Comments Concerning the Proposed Rulemaking to Revise Light-Duty Vehicle Greenhouse Gas Emissions Standards and Corporate Average Fuel Economy Standards: Technical Appendix

Referencing docket ID numbers:

EPA-HQ-OAR-2018-0283

NHTSA-2018-0067

FIGURE 1. Glider weight as a function of curb weight, for over 600 production vehicles

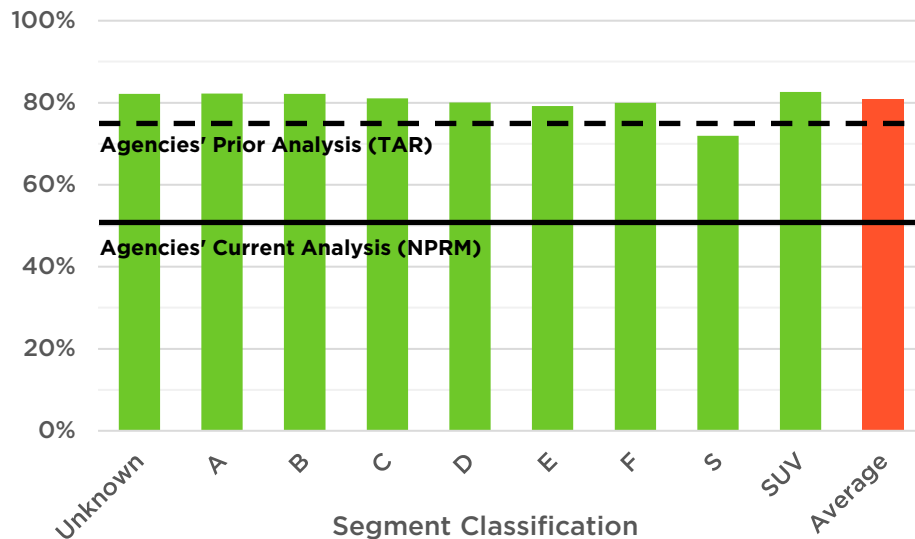
The share of a vehicle’s curb weight assigned to the “glider” is shown to be greater than the agencies’ current analysis for all vehicle segments. In fact, it is shown to be even greater than previous analyses for all segments except for S (Sport), for which lightweight materials are frequently already deployed—and even that class is only a marginally lower fraction (72 percent, compared to 75 percent in prior analyses).

In the NPRM, the agencies have determined that the “glider” of a vehicle, which is essentially everything minus the powertrain,⁹ accounts for only 50 percent of the vehicle’s curb weight. This is a substantial change from prior analyses, when the glider was assumed to represent 75 percent of the vehicle’s curb weight, and this change is not justified by the agencies in any way.¹⁰

Incredibly, the agencies’ own analysis in the NPRM disagrees with this fraction. The agencies base their analysis of the costs for lightweighting on two studies, one passenger car (2011 Honda Accord) and one light truck (2014 Chevrolet Silverado)—these studies themselves show the glider making up 79 percent of the vehicle in the case of the Accord (PRIA p. 393), and 73.6 percent of the curb weight for the Silverado (PRIA p. 399). Both of those percentages are substantially higher than 50 percent and essentially in line with the agencies’ prior analyses.

This assumption also disagrees with industry data, which shows that not only does the glider represent a more significant share of the curb weight than assumed by the agencies in this analysis, but it even exceeds the share of curb weight assumed in prior analyses (Figure XXX). It should be noted that for its

FIGURE 2. Agency manufacturing costs for mass reduction of cars, compared to source

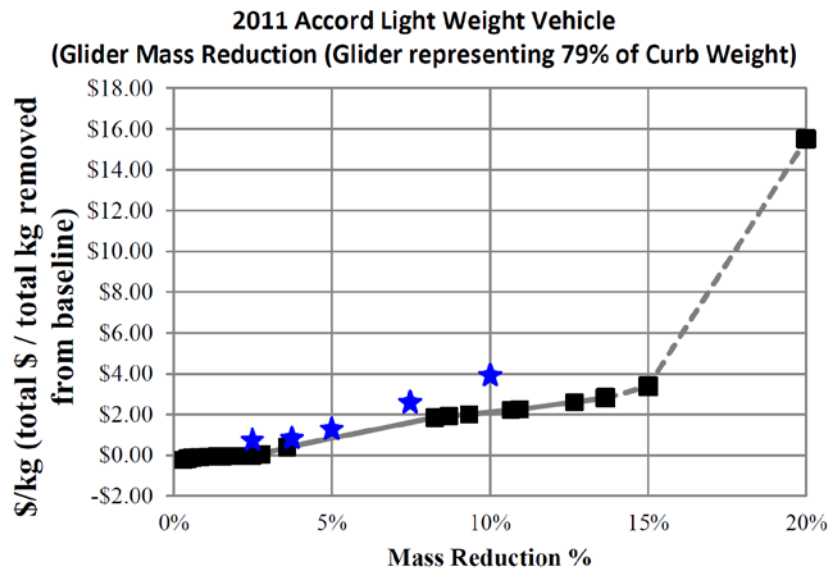
The agencies have based the costs for mass reduction on glider weight reduction; however, the need for more expensive materials and more advanced engineering and design strategies only results from the need for greater levels of absolute mass reduction on the vehicle. In effect, these costs have been derived from the assumption of reductions as great as 16.8 percent reduction in curb weight in the case of the Silverado (Singh et al. 2018) and as great as 18 percent reduction in curb weight in the case of the Honda Accord (Singh et al. 2016), but they have been applied to curb weight reductions approximately two-thirds that magnitude. This is completely invalid and significantly overstates the costs for mass reduction.

This is clearly demonstrable by examining the actual reports relied upon by the agencies, both of which refer to direct manufacturing costs as a function of curb vehicle weight, not just glider weight. The procedure the agencies have used to generate cost data is like arbitrarily scaling the x -axis by a factor of 1.5, yielding the same costs at two-thirds the amount of mass reduction. In fact, in the case of the

The agencies' costs for mass reduction (blue stars) are in direct conflict with the data cited as a source for those costs (black squares) because the agencies have improperly normalized them to different glider mass shares. This leads to costs for the highest levels of mass reduction that are nearly twice as large as those the agencies claim result from the source data.

FIGURE 3. Agency manufacturing costs for mass reduction of trucks, compared to source

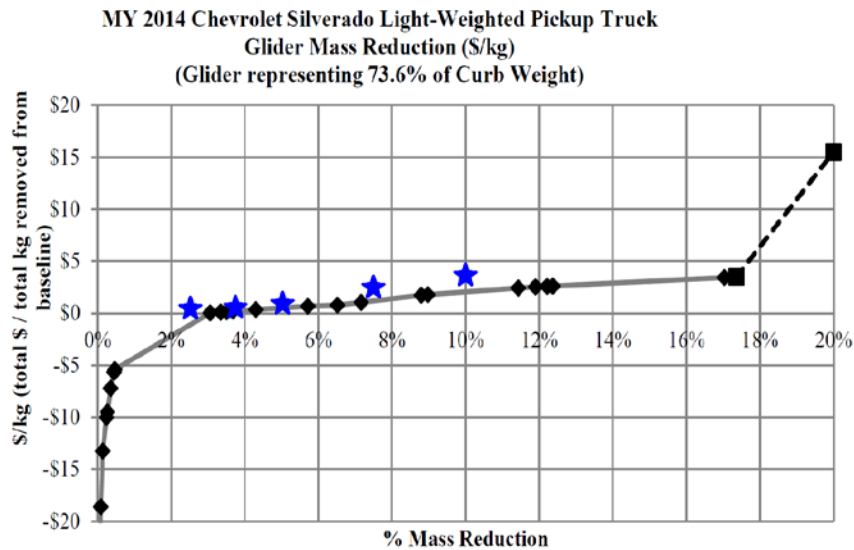
The agencies' costs for mass reduction (blue stars) are in direct conflict with the data cited as a source for those costs (black squares) because the agencies have improperly normalized them to different glider mass shares. This leads to costs for the highest levels of mass reduction that are approximately 70 percent larger than those the agencies claim result from the source data.

FIGURE 4. Fuel consumption relative to the “null vehicle,” as a function of curb weight reduction

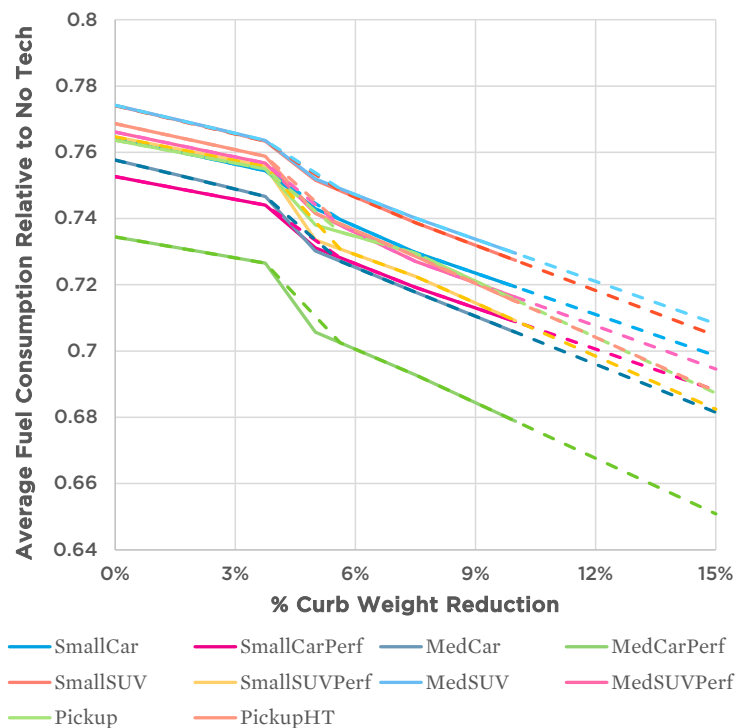
The Autonomie model results used as inputs to the Volpe model were based on the application of each level of mass reduction technology (MR1, MR2, etc.) to a glider share of 50 percent. Therefore, it is necessary to revise these values to reflect an increased level of curb weight reduction for each MR level. Reductions in fuel use as a function of mass reduction have a generally linear response, making it fairly straightforward to extrapolate the results from ANL to different levels of curb weight reduction. In Figure 4, we illustrate the average fuel consumption improvement for packages compared to the “null vehicle” as a function of mass reduction. While there is a notable “kink” in the data around 5 percent, this is the direct result of the agencies' determination not to hold performance constant for low levels of mass reduction, meaning that a significant share of the benefit of a few percent reduction in mass has gone towards improved performance rather than improved fuel economy, leaving a substantial

Consideration of a glider share of 75 percent enables a 50 percent greater potential in curb weight reduction, up to 15 percent from just 10 percent for the highest level of technology applied in the Volpe model.

Fuel consumption modeled with Autonomie for different vehicle classes is strongly linear (solid lines), allowing for clear interpolation and extrapolation of the data (dashed lines). Mass reduction less than 5 percent total curb weight reduction resulted in significantly greater fuel consumption than might be expected from that modeled at higher levels of mass reduction due to a lack of performance neutrality.

While only the average data is shown in Figure 4 for simplicity, we have considered and modified every single package for every single modeled vehicle, interpolating/extrapolating the results according to the improvement relative to an equivalent package with 0 mass reduction (e.g., “;;;;TURBO2;AT9;BISG;ROLL0;MR3;AERO0” vs. “;;;;TURBO2;AT9;BISG;ROLL0;MR0;AERO0”). It should be noted that no interpolation was necessary for the adjusted MR1 and MR3 results, which correspond exactly to the agencies’ MR2 and MR4 values.

In addition to adjusting the FCL_Improvements.csv file input into the Volpe model, it is also necessary to edit both the technology file and market data file (NHTSA 2018d). In the case of the technology file, we have simply corrected the glider share in the Parameters tab to reflect 0.75 (instead of 0.5), so that the costs for mass reduction are applied to an appropriate level of reduced mass. In the case of the market data file, we have had to correct the baseline vehicles who’ve “USED” a given level of mass

FIGURE 5. Production-weighted technology penetration for the 2016 model year

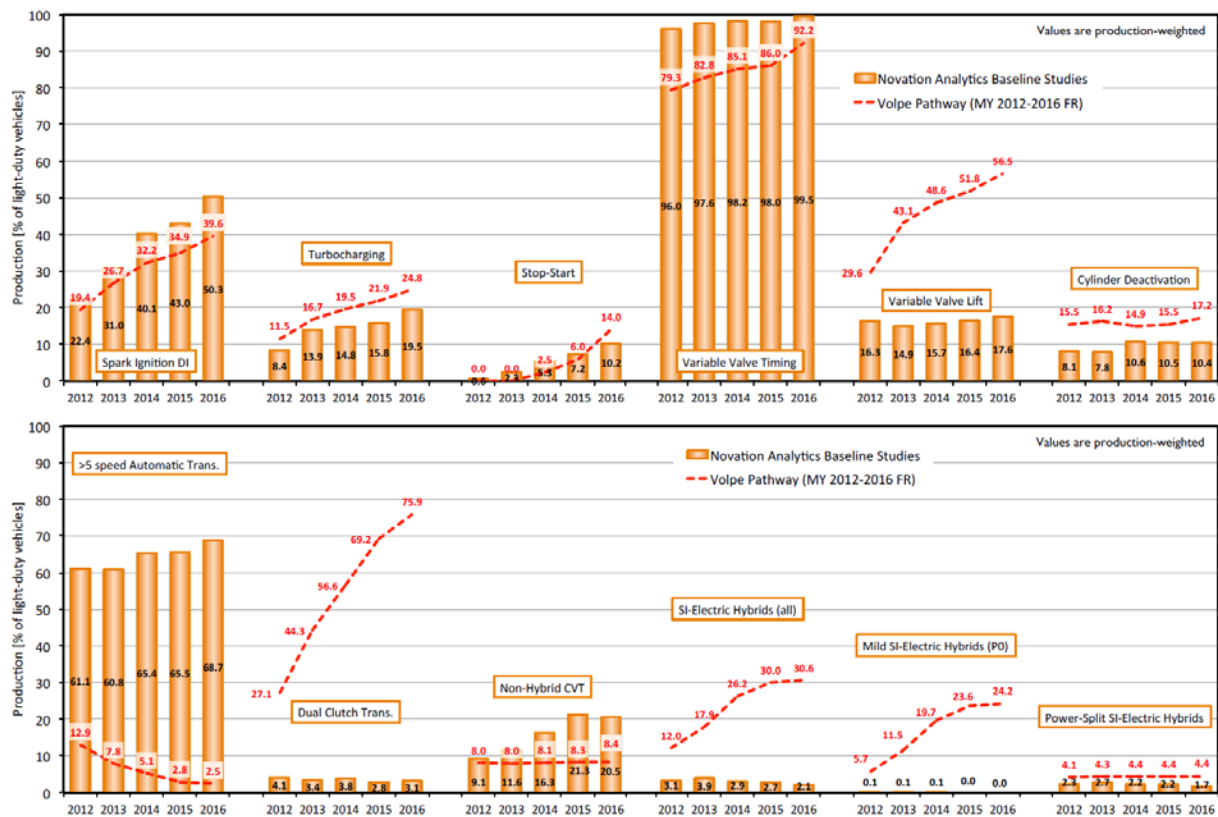
Industry has repeatedly erred in its analysis of this historical look at whether the pathways projected by either the OMEGA or Volpe models have come true (e.g., Novation Analytics 2016). Mistakenly, the authors of the Novation Analysis consider the agencies’ technology deployment rates as “over optimistic”; in truth, the data indicates that the agencies’ technology assumptions were **conservative**. It is clear from Figure 5 that the agencies’ pathways¹⁶ differ from actual technology deployed in a number of significant ways:

- **Cylinder control**—The Volpe model pathways projected that a higher penetration of both variable valve lift and cylinder deactivation would be needed for compliance; however, much lower penetrations of these technologies exist in the marketplace. The reason for this is simple—these technologies represent incremental steps up the cost ladder, and because manufacturers have been able to wring more out of the simpler, and cheaper, variable valve timing approach to cylinder control, **less** technology deployment was needed. This is representative of innovation used to reduce costs of compliance.
- **Engine technology**—Similar to the above example, a greater penetration of the less expensive SIDI exists in the market, as compared to turbocharged engines and stop-start, which are represented in the Volpe model as more expensive steps up the efficiency curve. The Volpe

A comparison of the pathway modeled by NHTSA to comply with the MY2012-2016 regulations and the actual technology deployed in the fleet. Note that much lower penetration of expensive and complex technologies was needed to comply with the regulation, indicating that the technologies being deployed are more cost-effective than the agencies anticipated.

FIGURE 6. 0-to-60 and passing time of modeled compact vehicles

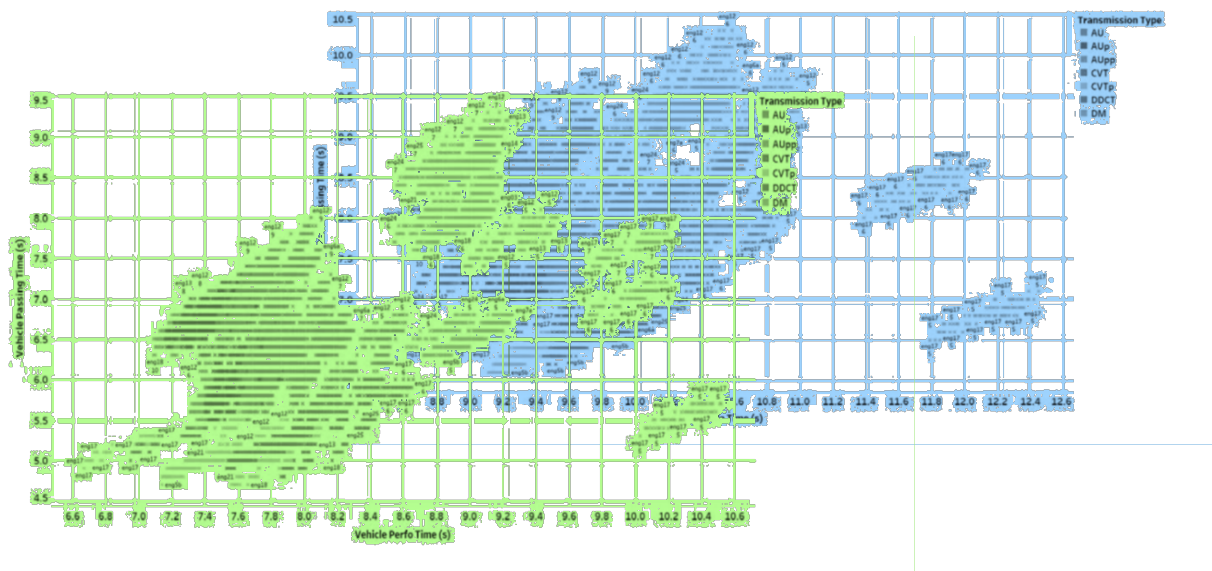
Performance “creep” in ANL’s Autonomie modeling results in such dramatic changes in vehicle performance characteristics that technology packages applied to non-performance compact vehicles (blue chart) show significant overlap with technology packages applied to performance compacts (green chart) (figures have been aligned to share common x-y coordinates). These performance improvements can significantly diminish the potential reductions in fuel consumption, but remain unaccounted for as a benefit in the Volpe model.

It is also worth noting in this discussion that the modelers at ANL have allowed significant performance “creep” in their modeling—rather than maintaining performance neutrality with applied technology, vehicle characteristics can vary dramatically through increased technology adoption (Sectoin 11.5, Islam et al. 2018b). While some performance creep may be reasonable, many of these packages are so wildly different that they actually cause an overlap between performance and non-performance vehicles of the same size class (Figure 6). Performance characteristics in the OMEGA model as a result of ALPHA full vehicle simulation do not vary as significantly and are approximately held fixed.

FIGURE 7. The total of banked credits for model years 2011-2015 under different scenarios

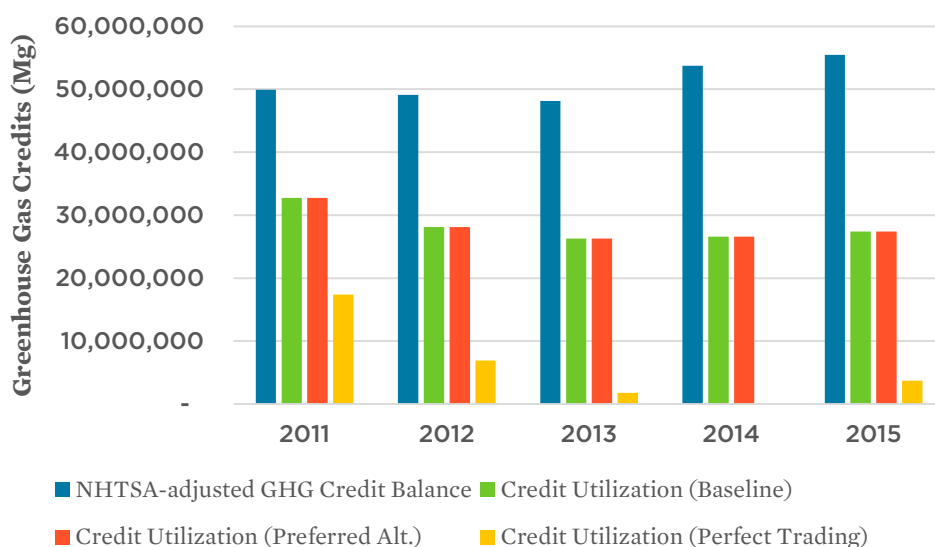
NHTSA attempted to model the greenhouse gas credit balance for manufacturers in MY2011-2015 based on anticipated usage (blue bars). However, for both the Baseline Standards and the Preferred Alternative (green and red bars, respectively), roughly half of manufacturers’ banked credits are allowed to expire, something which directly conflicts with manufacturers’ rationale for generating that overcompliance in the first place. This effect is even more pronounced when “perfect trading” is considered (yellow bars), where the industry as a whole is able to minimize its compliance costs—in that case, the industry is assumed by the model to use virtually none of its banked credits.

Figure 7 details both the credit bank defined by NHTSA staff in the Volpe model inputs and the credit trading outputs, compiled from the debugging files associated with running the model.²⁵ Here we show the credits utilized in three different modeling cases, compared to the default inputs: 1) the baseline case (EPA standards as they stand today), 2) the preferred alternative (holding standards flat after MY2020), and 3) the baseline case with perfect trading (further described below). Because the default inputs limit credit lifetime to 5 years and both the preferred alternative and the baseline case have the same standards through 2020 (the year when NHTSA’s GHG credit bank would expire), there is no difference whatsoever in credit application from the 2011-2015 bank between those two scenarios. However, it is clear in all scenarios that credits are not fully utilized.

As is apparent from the figure, significantly fewer credits are being applied by the model than are available to manufacturers. This is a serious flaw. Essentially, the model is saying that manufacturers are willing to let nearly half of their credits expire, which is simply not rational. What rational manufacturer would leave all of this money on the table? And why would a Board of Directors exercising their fiduciary responsibilities allow such financial folly to occur? Yet the model allowed 141 million Mg of credits to expire, while at the same time overcomplying with the regulations by 188 million Mg—clearly there is an arbitrary and outright irrational projection.

Because of deficiencies within the Volpe model's cost-effectiveness algorithm (Section I.A.2.b)(1)), modeling trading in such a way creates substantially less fleet deficits (by implicitly correcting them with current-year fleet trading), negating the need for using banked credits. This is why the utilization of banked credits in such modeling runs drops to virtually zero (Figure 7).

FIGURE 8. Fuel economy and technology penetration for conventional technologies, since 1975

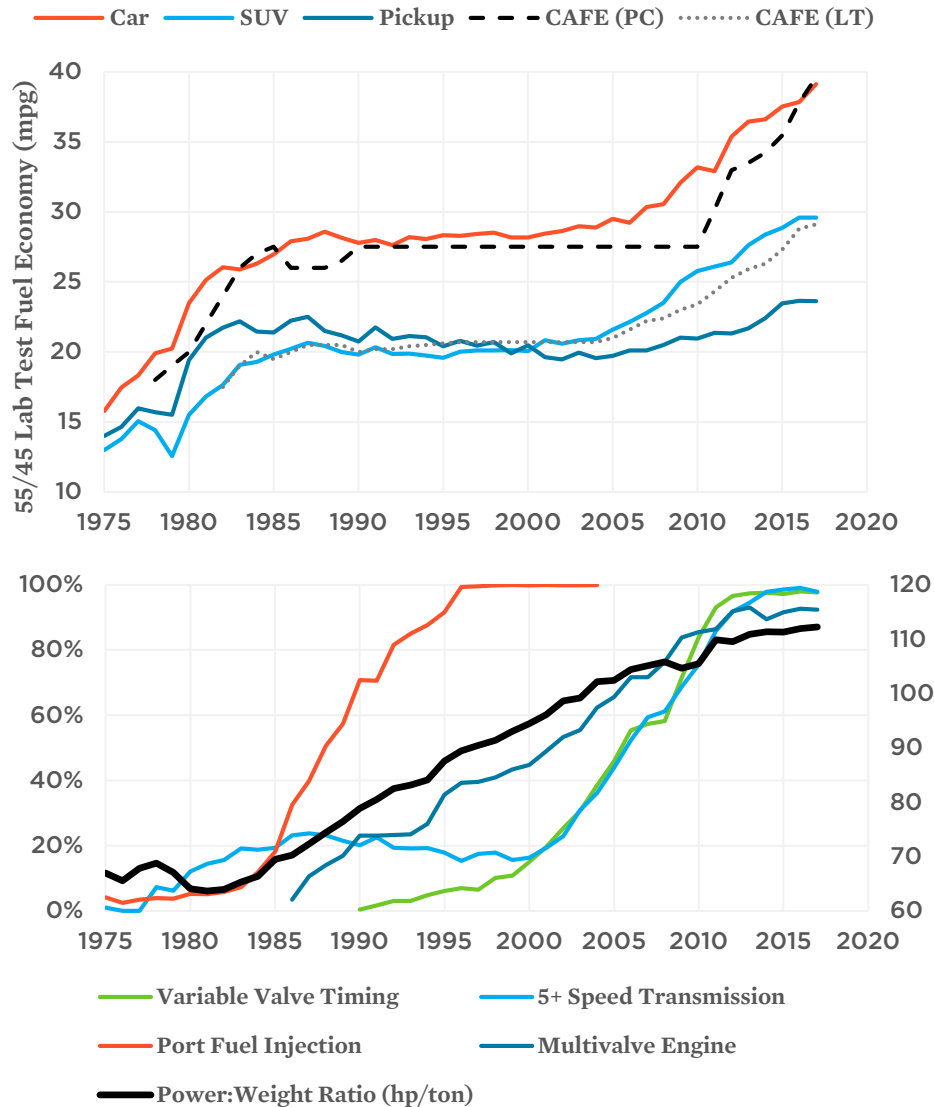
(Top) Lab test fuel economy has not historically changed irrespective of changes in regulatory stringency. (Bottom) At the same time, technology advances did not stop in the interim—rather, manufacturers applied cost-effective engine technologies like variable valve timing, port fuel injection, and multivalve engine design to improving performance (indicated by power-to-weight ratio, right axis), rather than fuel economy. Technologies like improved transmissions which did not translate as directly to improved performance characteristics did not see the same deployment until increases in fuel economy and emissions standards again necessitated them to be a (cost-effective) strategy for compliance.

This step defies historical precedent—without binding fuel economy and greenhouse gas emissions standards, manufacturers have not historically applied ***any*** technology towards improving fuel economy (Figure 8). Even at historic lows in gas prices, a number of cost-effective technologies were available that pay for themselves in short order (less than one year) and were capable of providing significant gains in fuel economy (e.g., NAS 1992). Manufacturers applied these technologies towards improved performance instead of improved fuel economy. It was not until California's landmark passage of California Assembly Bill 1493, which pushed the state to adopt global warming emissions standards for vehicles in 2004, and increased fuel economy standards first finalized in 2003, that manufacturers began to again improve fuel economy of their vehicles.

FIGURE 9. Credit balances under compliance with current standards through 2025

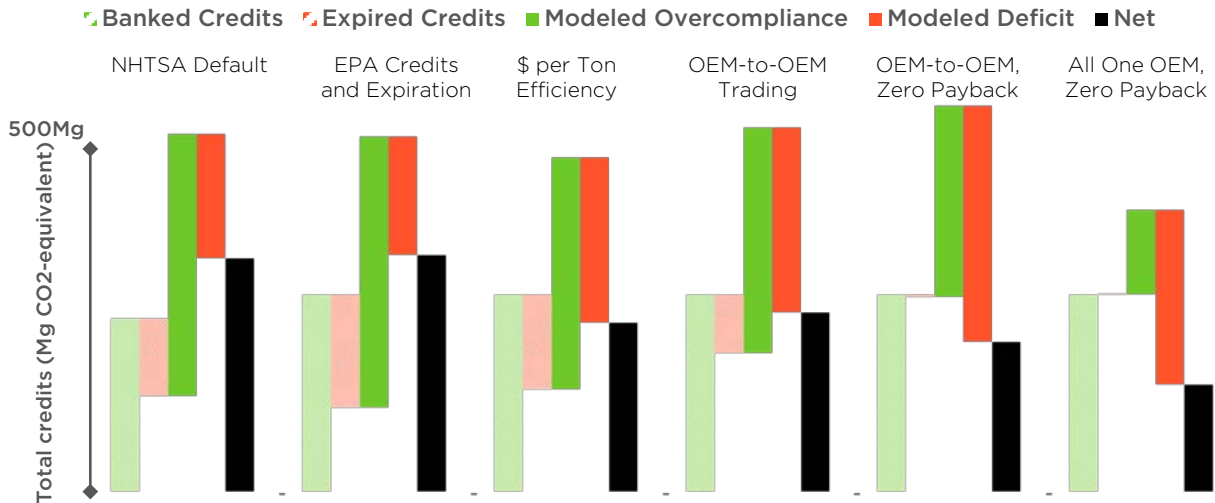
Compliance with the Baseline Standards using the Volpe model with different modifications helps illustrate the different suboptimal strategies the model utilizes for manufacturers and how that can be corrected through modification. Under improvements in credit trading, increased prioritization of credits, and improved algorithm for assessing technology efficiency, it is possible to reduce aggregate overcompliance by more than half (54 percent).

Figure 9 depicts credit activity while complying with the 2025 Baseline Standards,³¹ under different modifications to the Volpe model: 1) the default scenario; 2) utilizing EPA’s actual credit bank and one-time carryforward exemption (Appendix A-3); 3) modifying the efficiency algorithm to weight

FIGURE 10. New light-duty vehicle price, by class, in constant dollars (2007\$)

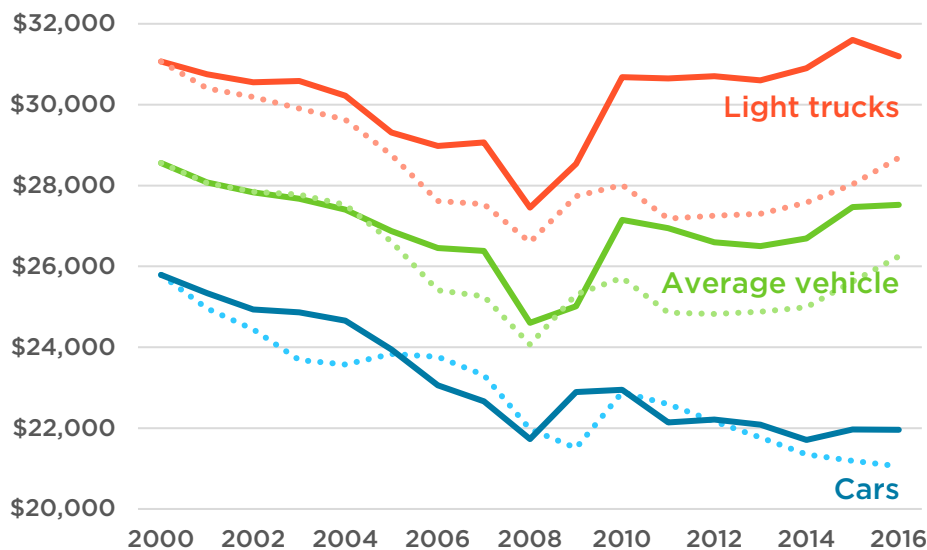
A comparison of the prices for new light-duty vehicles (solid lines) and the expected consumer price based solely on improvements in quality (dotted lines; see BLS n.d.). The price for new cars largely maps the improvements in quality, but a growing gap appears in the light truck segment, which is increasingly mirrored in the new average vehicle price as the share of light trucks has increased.

changes in price one would expect for improvements in quality (Figure 10).³⁴ This supports previous agency conclusions that “the low-priced vehicle segment still exists...[but] appear to be gaining more content” (Section B.1.6.4, EPA 2016e). This has also been affirmed by recent work from Consumers Union (Comings and Allison 2017).
